Access Compliance Report Public Rights-of-Way (Curb Ramps)

Intersection ID: 19082Main Street:NATIONS_FORD_RDCross Street:SHARVIEW_CRLocation:NWADA ID: A94F5B504C73Ramp Type:PerpDiagInitial Pass/Fail:FailOverall Compliance:NoSeverity Score:22.5

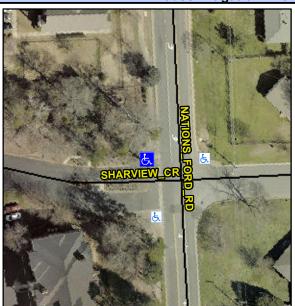
Field Measurements/Component Compliance					
Compliance Description		Data	Comp	liance Description	Data
N/A	Ramp Length (in)	77.0	No	Ramp Slope (%)	9.2
No	Ramp Width (in)	45.0	No	Ramp XSlope (%)	2.2
N/A	Flare Type LT	N/A	N/A	Flare Type RT	N/A
N/A	Flare Slope LT (%)	N/A	N/A	Flare Slope RT (%)	N/A
N/A	Flare Traversable LT?	N/A	N/A	Flare Traversable RT?	N/A
N/A	Landing Length (in)	N/A	N/A	DWS Provided?	N/A
N/A	Landing Width (in)	N/A	N/A	DWS Contrast?	N/A
N/A	Landing Slope (%)	N/A	N/A	DWS Length (in)	N/A
N/A	Landing X Slope (%)	N/A	N/A	DWS Full Width?	N/A
N/A	Landing Curb? (Y/N)	N/A	N/A	DWS Offset (in)	N/A
N/A	Shared Landing?	N/A			
N/A	Gutter Ponding?	N/A	N/A	Gutter Slope (%)	N/A
N/A	Gutter Lip Ht (in)	N/A	N/A	Gutter X Slope (%)	N/A
N/A	Painted X Walk1?	No	N/A	Painted X Walk2?	No
	X Walk 1 Direction	To S		X Walk 2 Direction	To E
N/A	X Walk 1 Width (in)	N/A	N/A	X Walk 2 Width (in)	N/A
	X Walk 1 Slope (%)	1.2		X Walk 2 Slope (%)	5.4

X Walk 1 X Slope (%)	5.7		X Walk 2 X Slope (%)	0.9
N/A	Ramp inside XWalk1?	N/A	N/A	Ramp inside XWalk2?	N/A
	Road Slope (%)	4.9	N/A	Clear Space?	N/A
	Road X Slope (%)	1.3	N/A	Clear Space to XWalk (in)	N/A
N/A	Any Obstructions?	N/A	N/A	Storm Grate/Utility Hazard?	N/A
	Obstruction Type			Storm Grate/Utility Type	
		N/A			N/A
			Yes	Surface Condition? (G/P)	Good
100

SHARVIEW CT StopSign NATIONS FORD RD None Possible Solutions:

Remove & Replace Curb Ramp With Two New Directional Ramps or Equivalent.

R304.5.1, R304.2.2, R304.5.3
